ITEM FOR ENVIRONMENTAL BOARD AGENDA

NAME & NUMBER
OF PROJECT: REGENTS WEST CAMPUS
SP-2012-0427C

SUBJECT: Regents West Campus - SP-2012-0427C

REGENTS WEST CAMPUS
CUT - FILL EXHIBIT
3231 TRAVIS COUNTRY CIRCLE
AUSTIN, TEXAS 78735

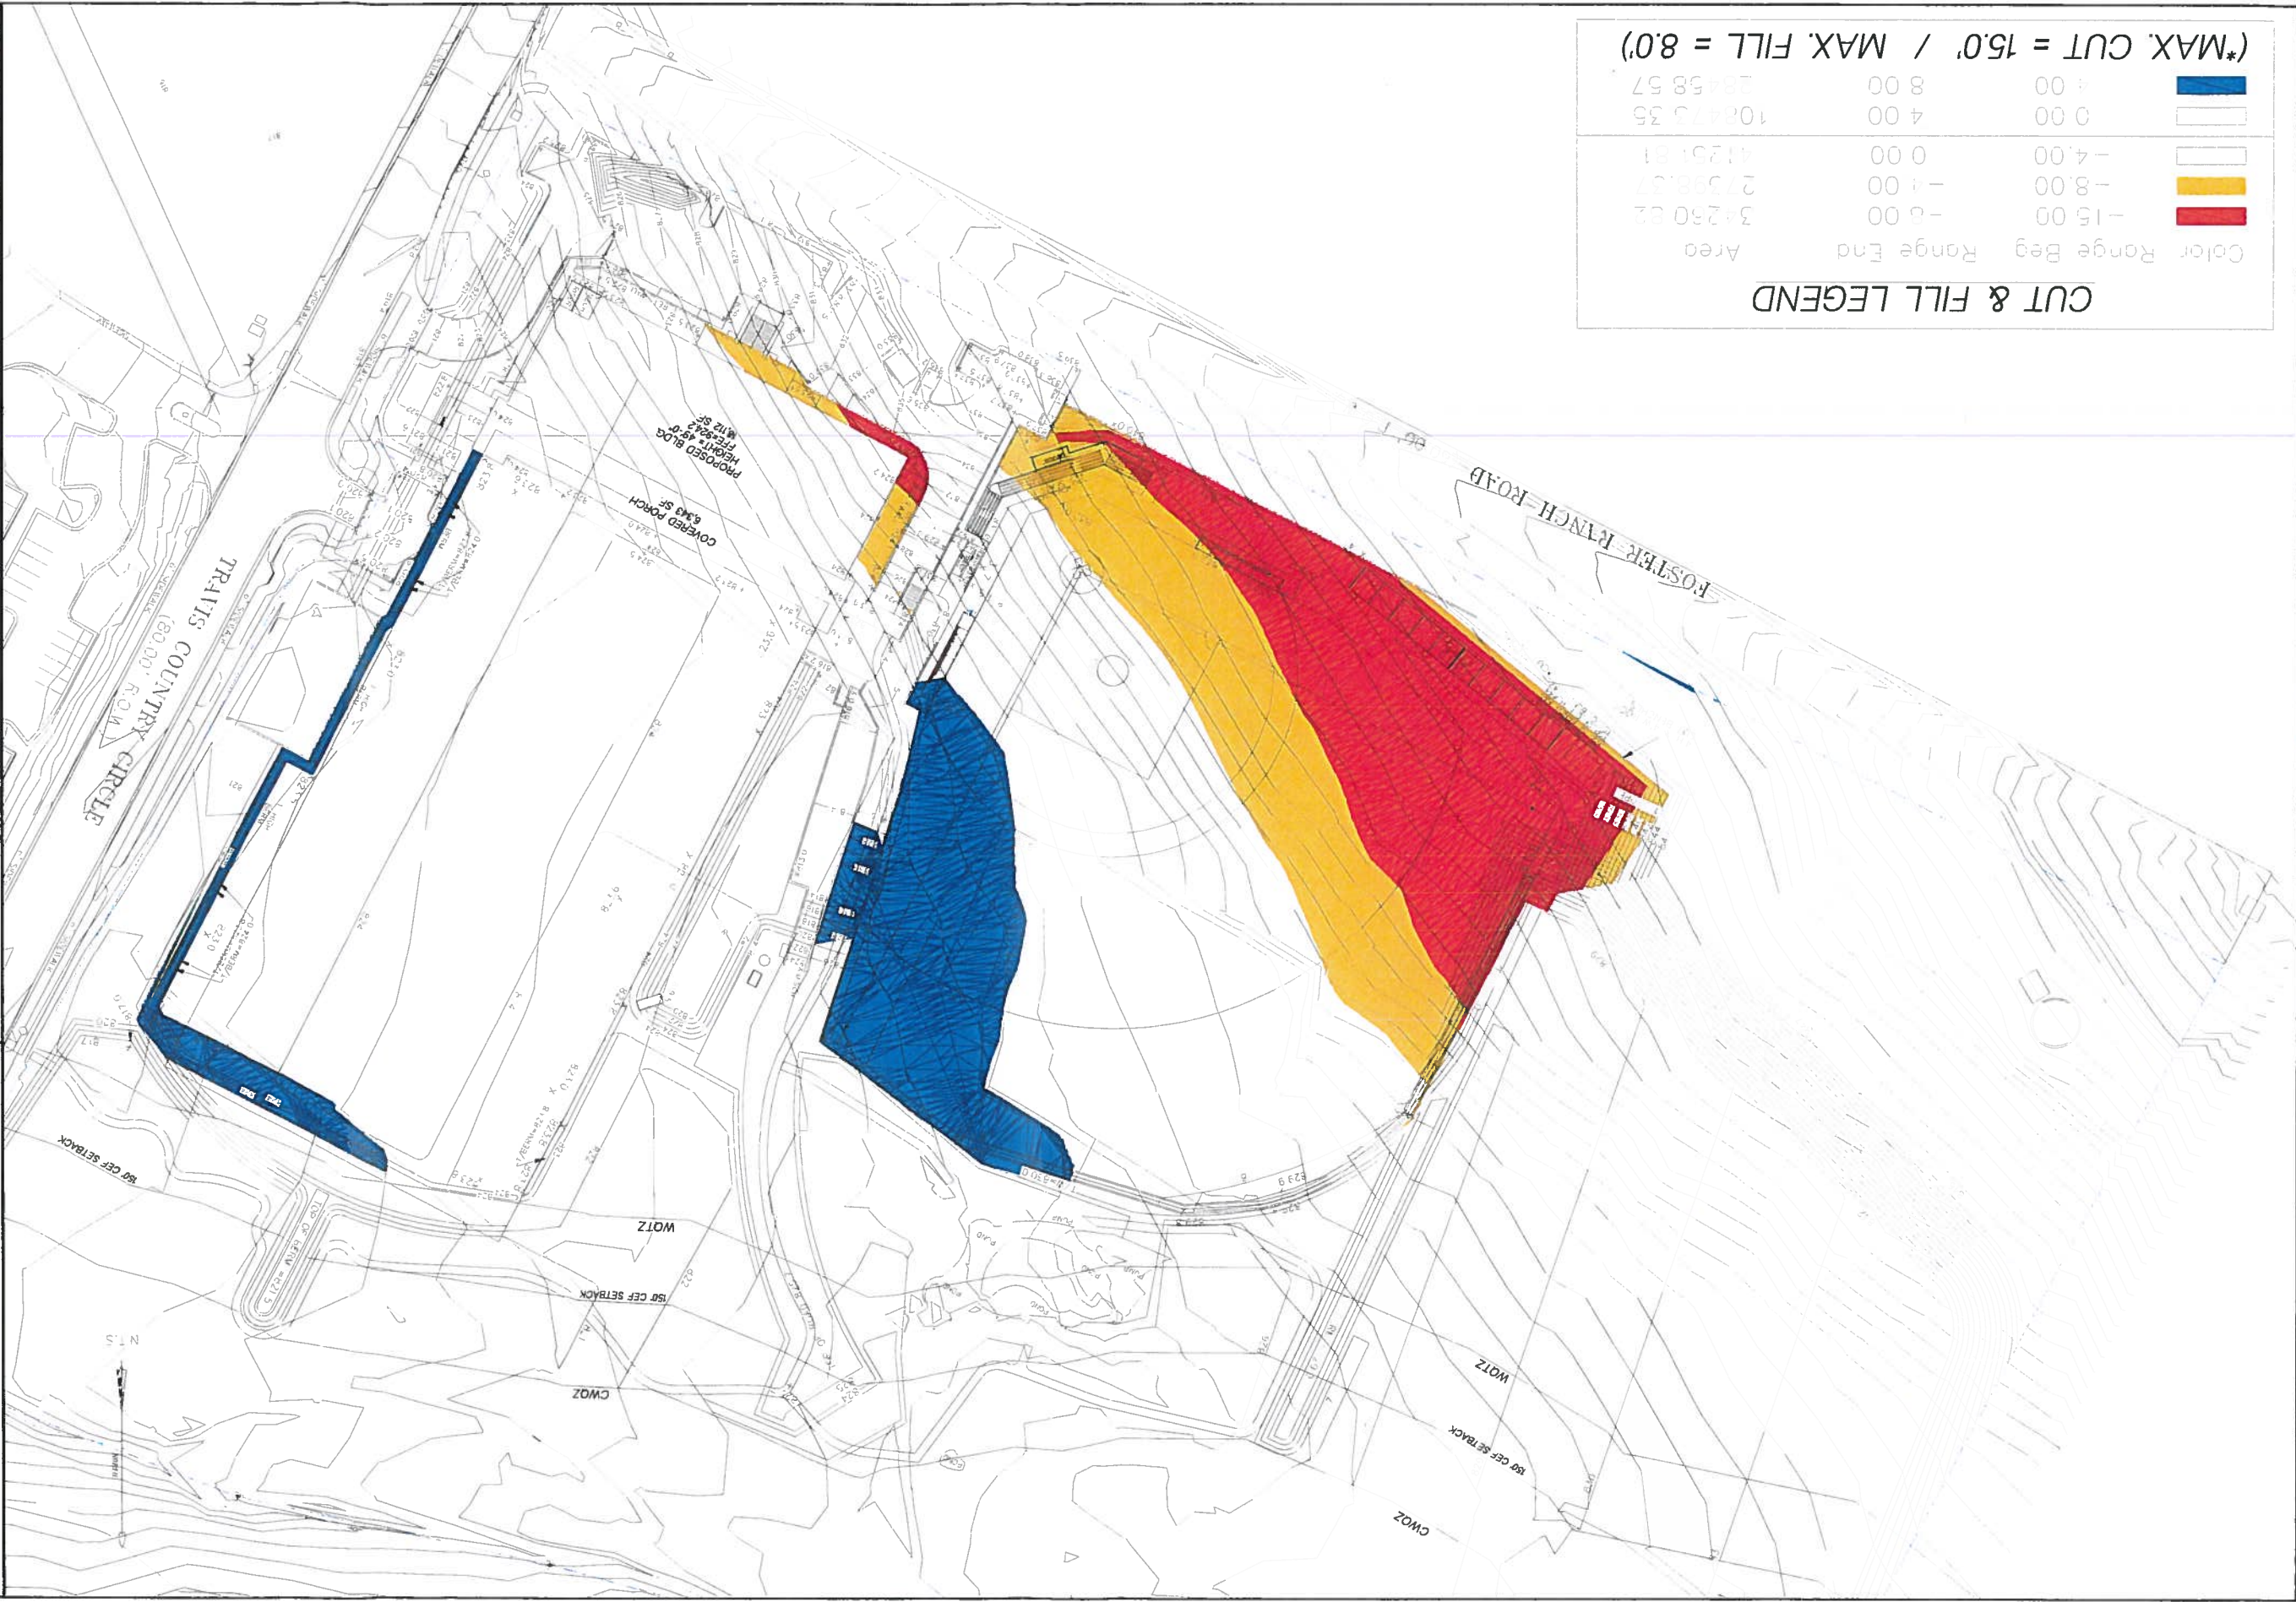
On the November 20, 2013 agenda is a request for the consideration of two variances from LDC 25-8-341 - To allow cut greater than 4 feet not to exceed 15 feet and from LDC 25-8-342 - To allow fill greater than 4 feet not to exceed 8 feet.

1. To allow cut greater than 4 feet not to exceed 15 feet. LDC 25-8-341.
2. To allow fill greater than 4 feet not to exceed 8 feet. LDC 25-8-342.

- 1) Restrict future development on the west campus by limiting the overall impervious cover to 15% of the net site area.
- 2) The applicant has agreed to and already provided a site specific turf management plan/IPM for the football field proposed that details the use of fertilizer and pesticide application, soil maintenance, and irrigation schedule related to its use as a re-irrigation area for the required SOS water quality control.
